Gunnison County Environmental Health Board

**GUNNISON COUNTY, COLORADO
COMMUNITY DEVELOPMENT DEPARTMENT, ENVIRONMENTAL
HEALTH OFFICE STAFF REPORT**

Application No: OWTS-22-00005
 Date application scheduled with EH Board: April 14, 2022
 Prepared by: Rebecca Ricord, Plans Examiner

STEVENS RESIDENTIAL O.W.T.S.
38 ASPEN STREET
GUNNISON COUNTY, CO

1 SITE PLAN
3/32" = 1'-0"

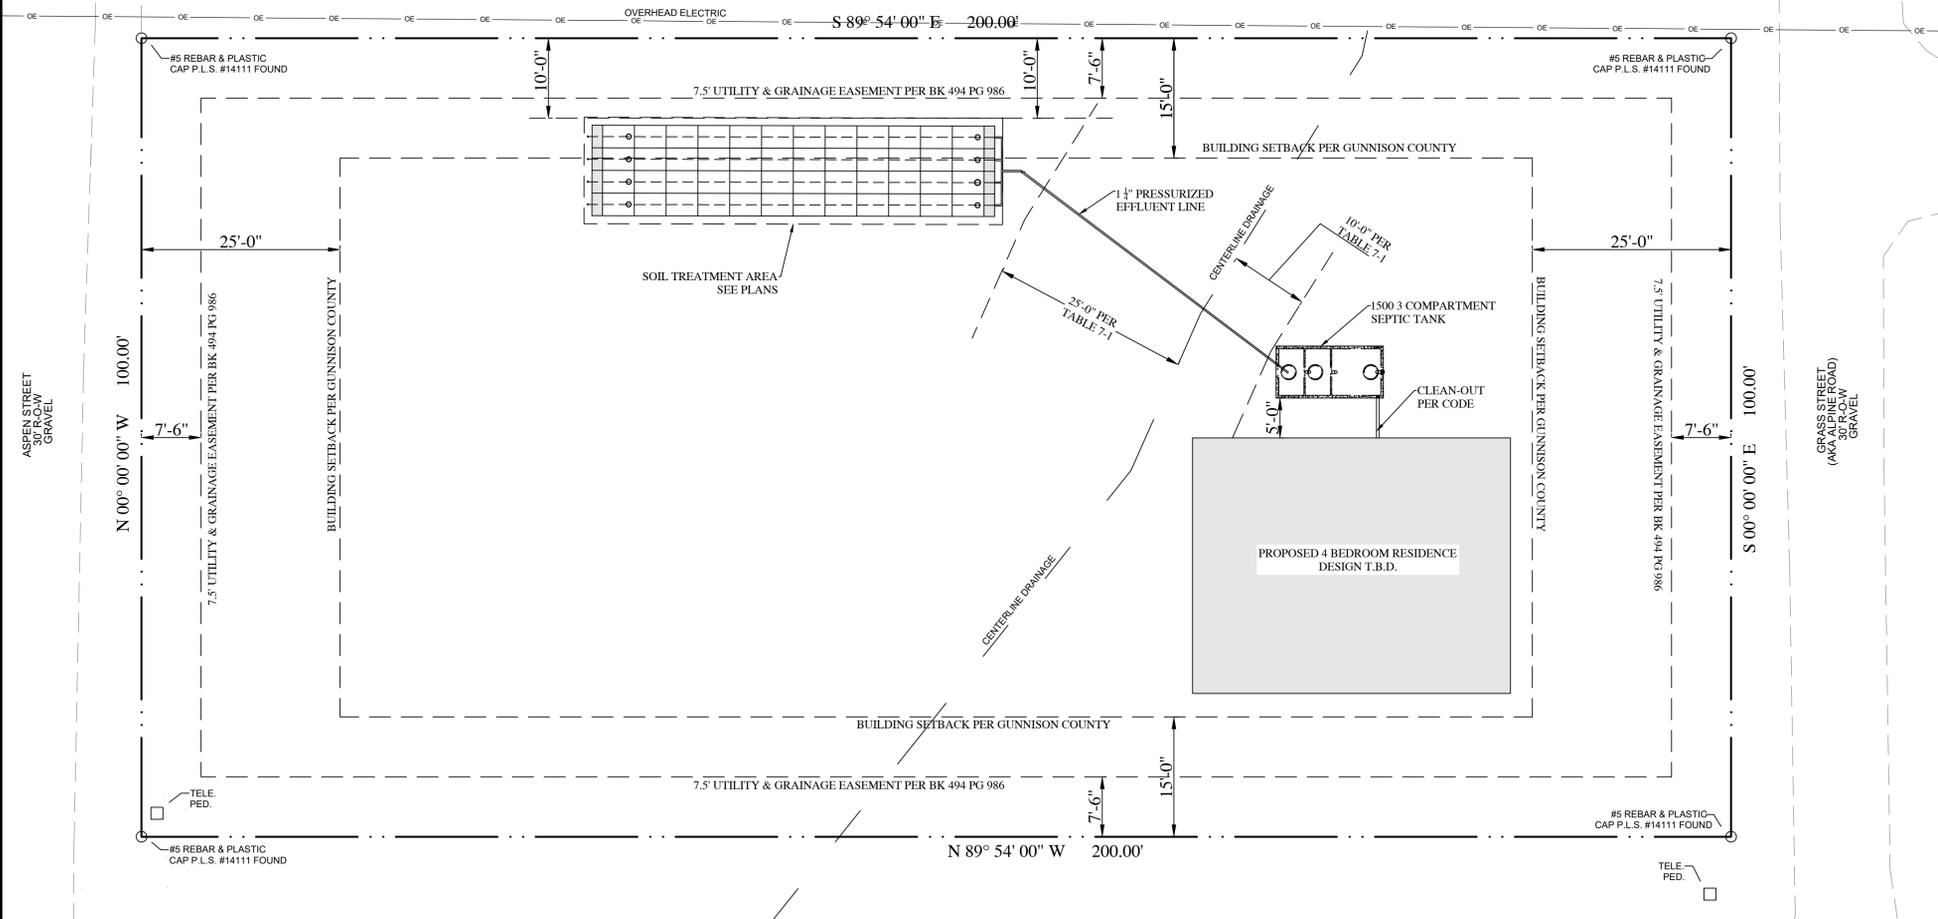
Prohibitions on the granting of variance requests:	Staff comments:
No variance shall be issued where the property can accommodate a conforming OWTS. Section 3.M.2.a.	The OWTS will conform to the technical, design and setback distance requirements of the OWTS Regulations. The variance request is for a system on a parcel less than one acre.
No variance shall be issued to mitigate an error in construction involving any element of property improvements. Section 3.M.2.b.	N/A
No variance shall be allowed on the grounds of cost of compliance. Section 3.M.2.c.	N/A
No variance shall be issued if it will result in a setback reduction to an offsite physical feature that does not conform to the minimum setbacks defined in Table 7-1 of this regulation without proof of compliance of Section 3.M.5. Section 3.M.2.d.	The minimum setbacks to on-site and off-site physical features appear to be met with the proposed development plan.

It appears that the proposed OWTS design meets the design criteria and setback distance requirements of the Gunnison County OWTS Regulations. The existing public water service eliminates concern regarding setback distances to water wells. Staff recommends approval of the Stevens application for a variance to the Gunnison County OWTS Regulations, Section 3.A.9, to install the proposed OWTS on Lot 10, Block 5 of the Chair Mountain Ranch Subdivision.
